ICTAP-CAO-DESIGNREV-001-R0

EBRCS Design Review

February 2008

## **East Bay Regional Communications System Design Review Report**

Figure B - 1 Alameda County - East

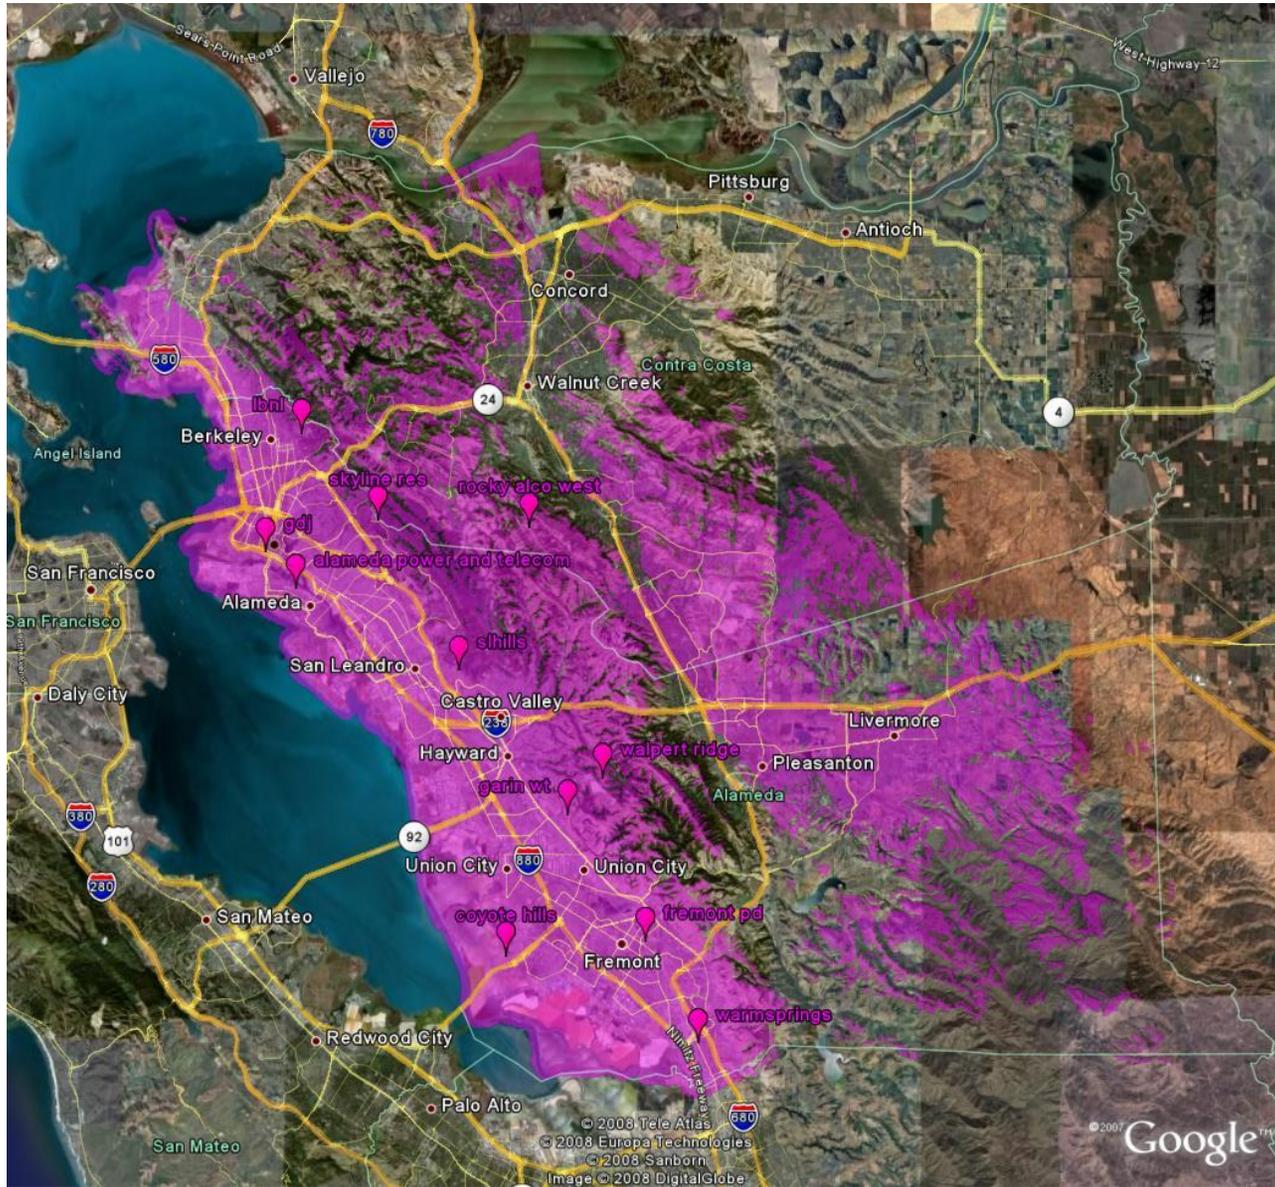
**ICTAP Comment:** Walpert Ridge is in the ALCO East cell, however this site seems to provide better coverage into the ALCO West cell. The Walpert Ridge site is a site that is used on the existing Alameda County simulcast system.

**ICTAP Comment:** There is concern about the city of San Ramon and adjacent areas being directly between two cells, CCC Central and CCC East. The concern is that any small local incident in San Ramon will require activation of radios on both cells.

**ICTAP Comment:** Upon inspection of the portable coverage for the EBRCS system, ICTAP would like to make note of the coverage holes located in the southeastern corner of Alameda County. From our understanding, the Crane Ridge site was placed to provide some coverage to a couple of local roads in the area, and it seems to cover more area north of the site than south. ICTAP is aware that this is a low population area and would just like to make sure the East Bay doesn't have a need for coverage in the area south of Crane Ridge along the county border.

**ICTAP:** *We agree that the Walpert Ridge site did not provide adequate penetration in the existing system and there would be more value to the coverage of the ALCO West cell if a site with better penetration into the City of Hayward is utilized. In the latest design, Walpert Ridge has been moved into the ALCO West cell and the Garin Water Tank is used for coverage into the City of Hayward.*
